# REPORT TO THE CALGARY PLANNING COMMISSION

DEVELOPMENT PERMIT	ITEM NO: 10
CPC DATE:	2009 March 19
DP NO:	DP2008-2645

PROPOSAL: Hotel (157 Units), Multi-Residential Development (90 Units), Restaurant: Licensed – Small/Medium, Retail	
APPLICANT: Torode Commercial	OWNER: TRL Real Estate Syndicate (05) Ltd.
MUNICIPAL ADDRESS: 321 11 Av SE 323 11 Av SE 327 11 Av SE 314 12 Av SE 322 12 Av SE 328 12 Av SE	LEGAL DESCRIPTION C;79;10,11 C;79;12,13 C;79;14,15 C;79;6-9,31-35 C;79;29,30 C;79;26-28  (Map15 C)
EXISTING LAND USE DISTRICT(S):CC-X Centre City Mixed Use District	
AREA OF SITE: 0.64 ha ± (1.57 ac ±)	
CURRENT DEVELOPMENT: Undeveloped gravel site with vacant Enoch Sales House situated at the southwest corner of the site

SECOND LEVEL TERRACE LIGHTING

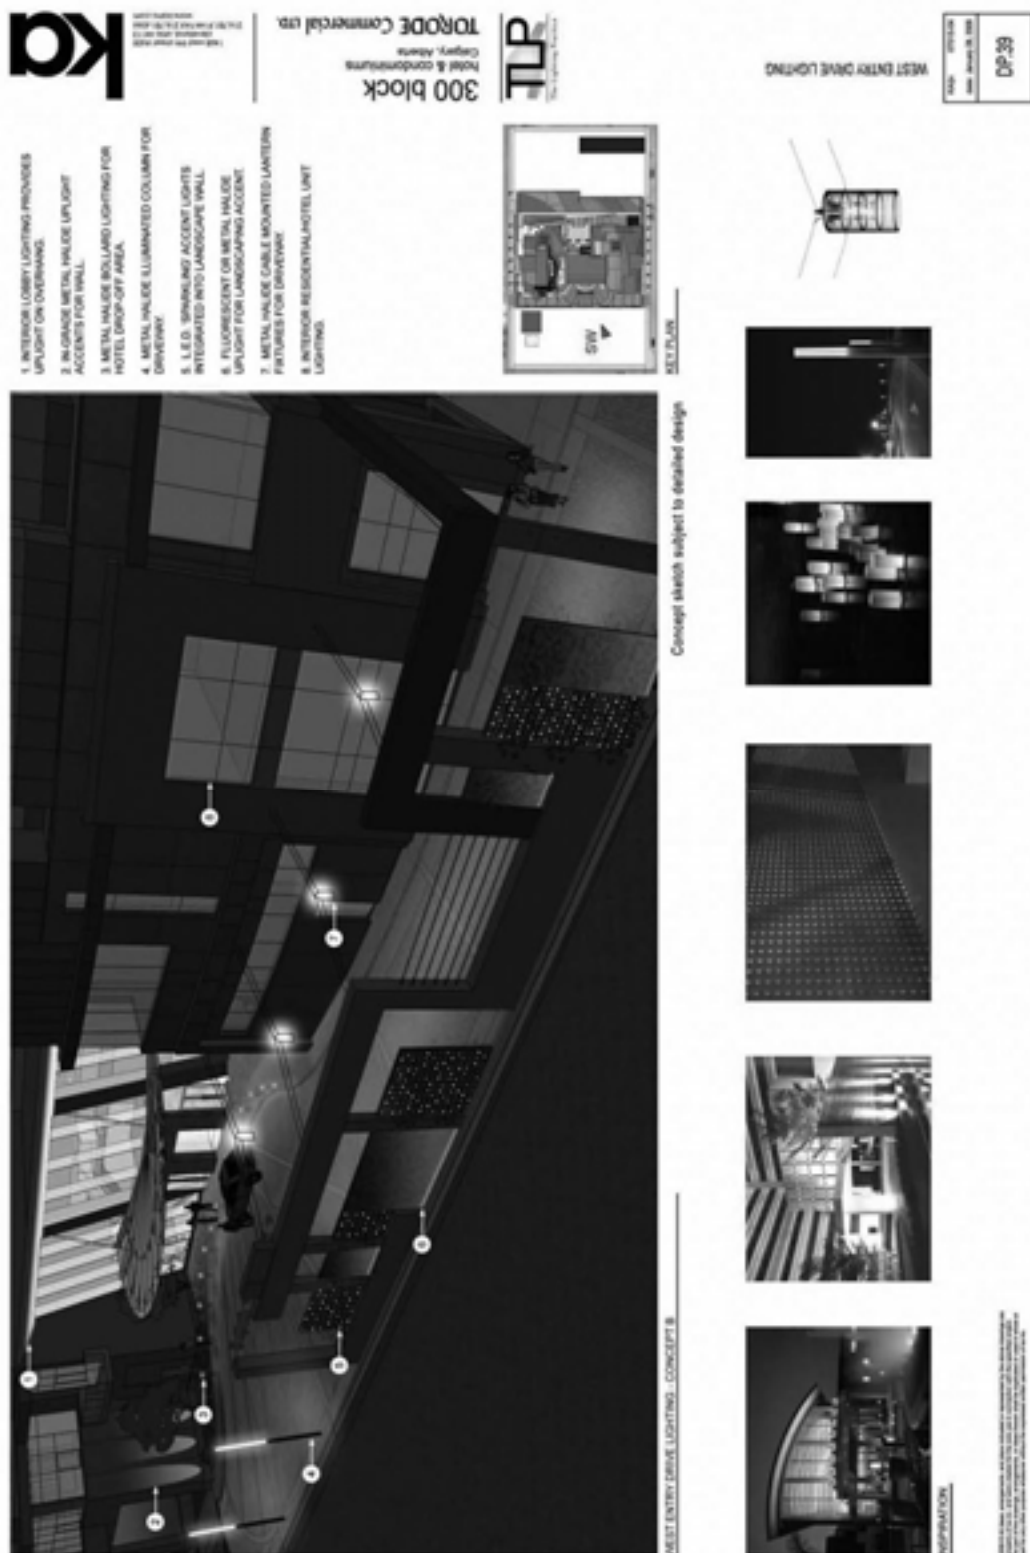
- a. Remove the metal halide tree accent lights from within the road right of way
